[Docket No. 2000–CE–44–AD; Amendment 39–12920; AD 2002–21–13]

Airworthiness Directives; Raytheon Aircraft Company Beech Models 35, 35R, A35, and B35 Airplanes

ACTION: Final rule.

Figure 1

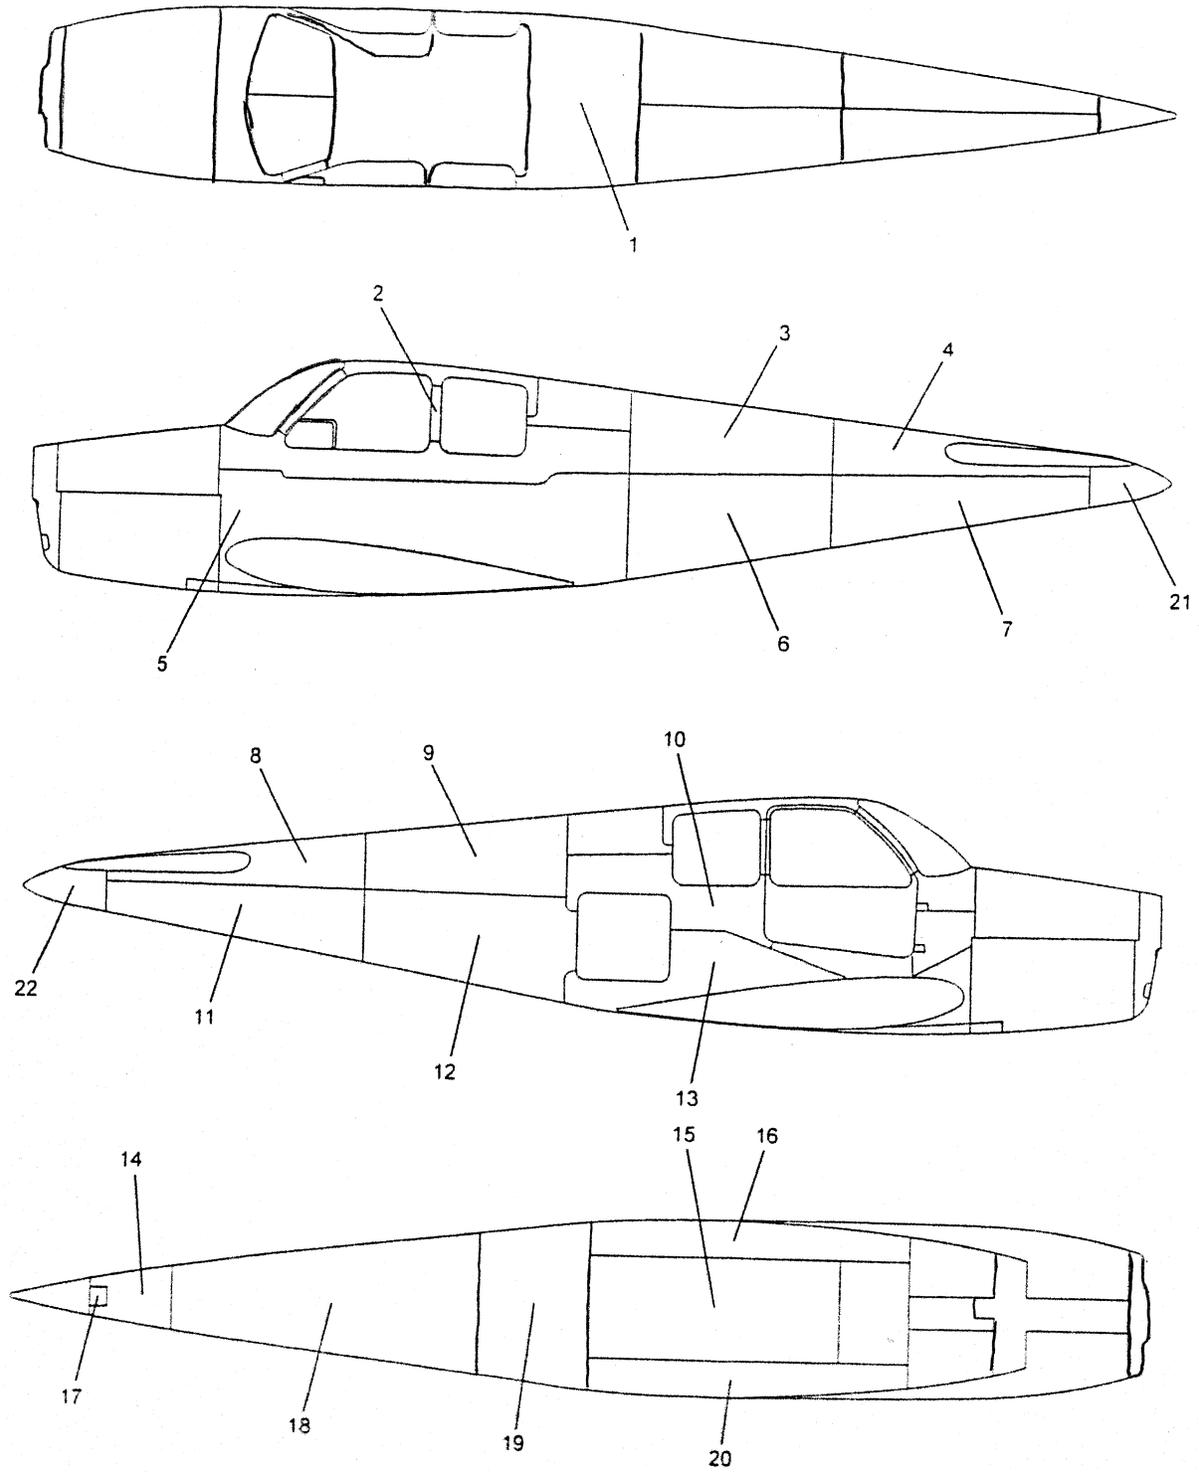
We also concur that there are differences in skin thickness. We are adding to the final rule AD action reference to the different skin thicknesses that are specific to each airplane serial number and the location (fuselage stations) of each affected skin part number.

(5) Visually inspect the empennage, aft fuselage, and ruddervator control system for damage: (i) Part of this is an inspection of the aft fuselage skin for wrinkles or cracks. Specific skin thicknesses are presented in Figures 1 and 2 of this AD. The skin thickness measurement is not repetitive. (ii) The inspection and setting of the travels on the elevator and elevator trim tabs are not repetitive. (iii) Repair or replace any damaged parts and set the elevator controls, rudder and tab system controls, cable tensions, and rigging.	Inspect within the next 100 hours TIS after the last inspection required by AD 94-20-04 or within the next 25 hours TIS after December 10, 2002 (the effective date of this AD), whichever occurs later, and thereafter at intervals not to exceed 100 hours TIS, except for the skin thickness measurement and the inspection and setting of the travels on the elevator and elevator trim tabs, which are one-time actions. Accomplish any repairs, replacements, and adjustments prior to further flight after the applicable inspection.	Accomplish the inspection and repairs or replacements in accordance with the procedures in paragraphs (5)(a) through (5)(f) of the ACCOMPLISHMENT INSTRUCTIONS section of Raytheon Service Bulletin No. SB 27-3358, Issued: February, 2000, and use a digital ultrasonic skin tester or equivalent skin tester or direct methods that utilize calipers and micrometers. Specific skin thicknesses are contained in Figures 1 and 2 of this AD.

We are changing the final rule AD action to state that you must accomplish this measurement in accordance with a digital ultrasonic skin tester or equivalent skin tester or by direct methods that utilize calipers and micrometers.
